January 26, 1993
C321-93-2007
5000-93-0012

Subject: Oyster Creek Nuclear Generating Station (OCNGS)
Operating License No. DPR-50
Docket No. 50-219
Reactor Vessel Fracture Mechanics Analysis for Upper
Shelf Energy Requirements

FIGURE 1

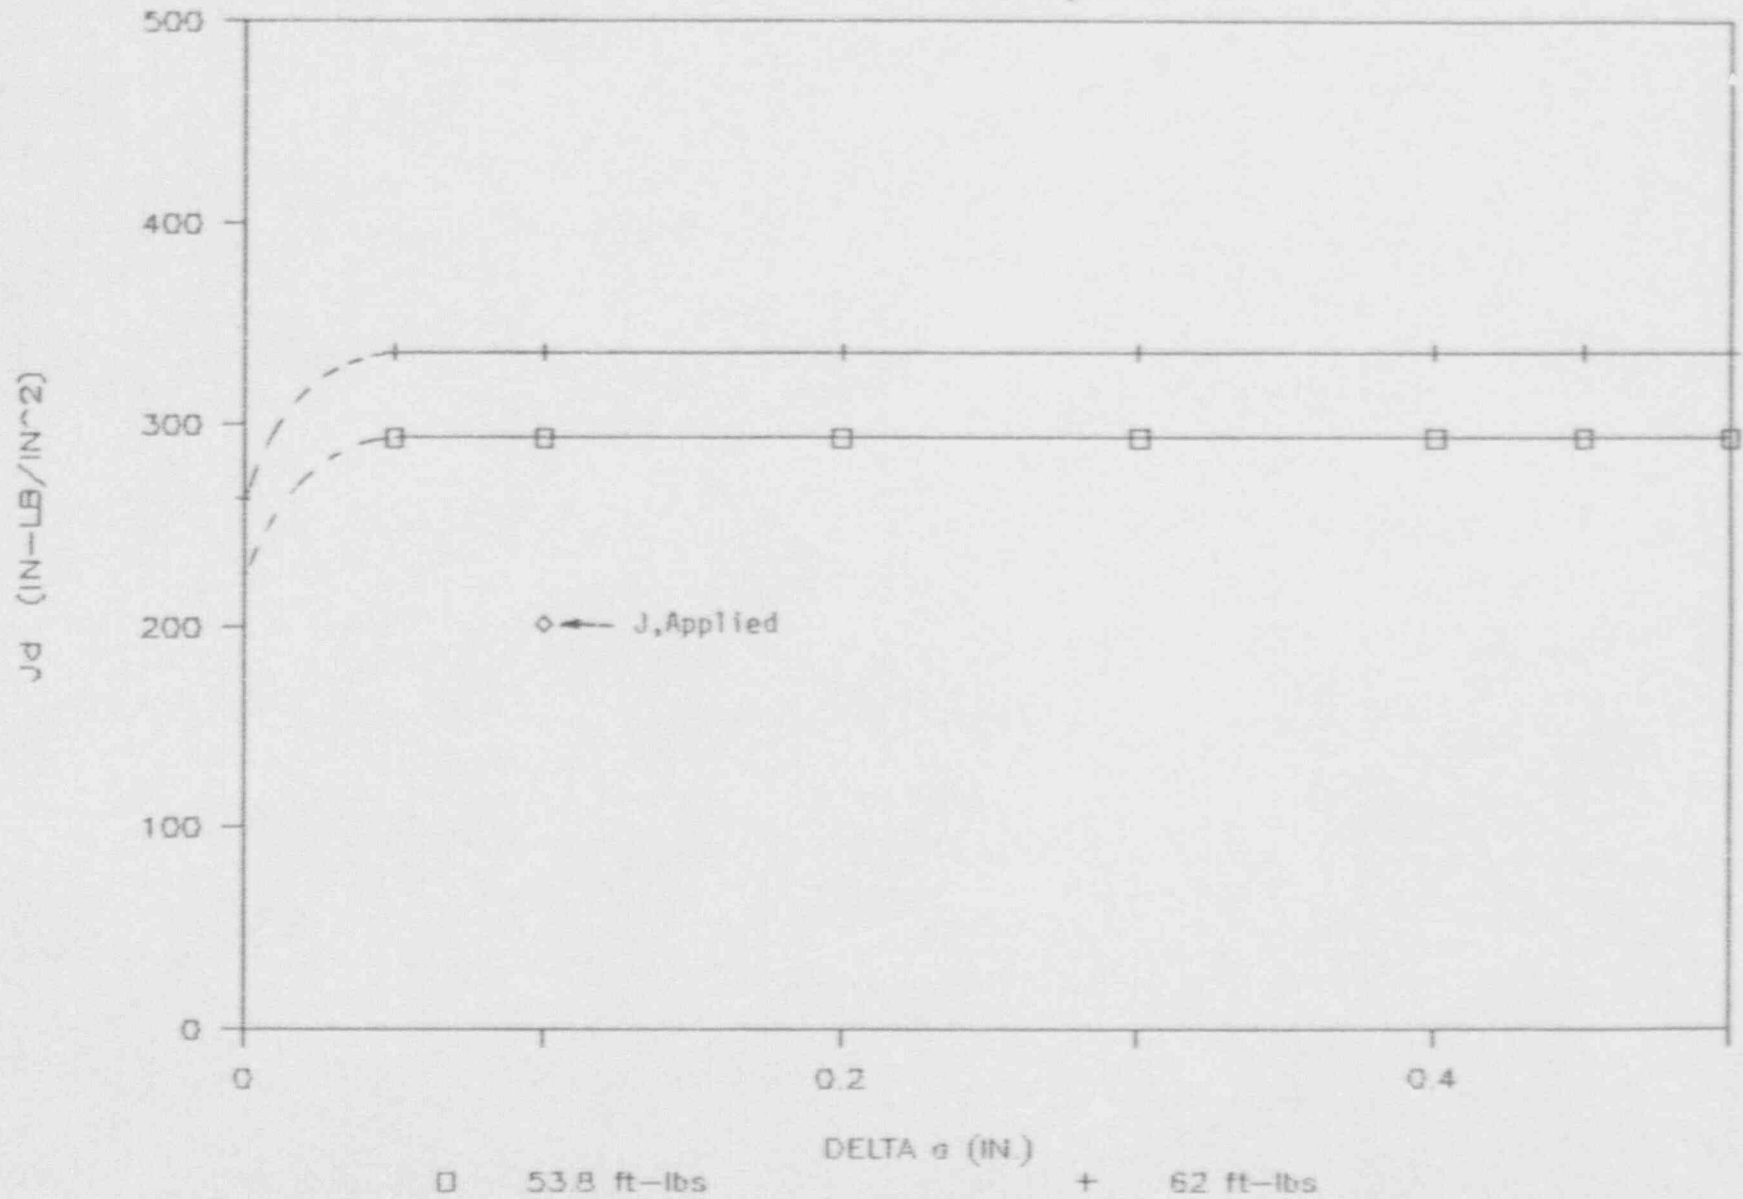
Your letter dated November 9, 1992 requested postulated interior axial flaws to be evaluated to determine the adequacy of the upper shelf toughness for the Oyster Creek reactor vessel based material.

In the analysis two (2) Charpy-V-Notch (CVN) energy levels were considered: 53.8 ft-lbs. and 62 ft-lbs. The first value corresponds to 1/.65 (per the conversion factor given in Standard Review Plan 5.3.2) of the 35 ft-lbs. transverse direction CVN value used in our evaluation of a circumferential crack reported in the aforementioned report. The 62 ft-lbs. is the lowest end-of-life predicted CVN value in the longitudinal direction. Figures 1 (J_0 analysis) and 2 (stability evaluation) show the results for Level A and B condition evaluations. It is seen that the applicable criteria are satisfied in each case.
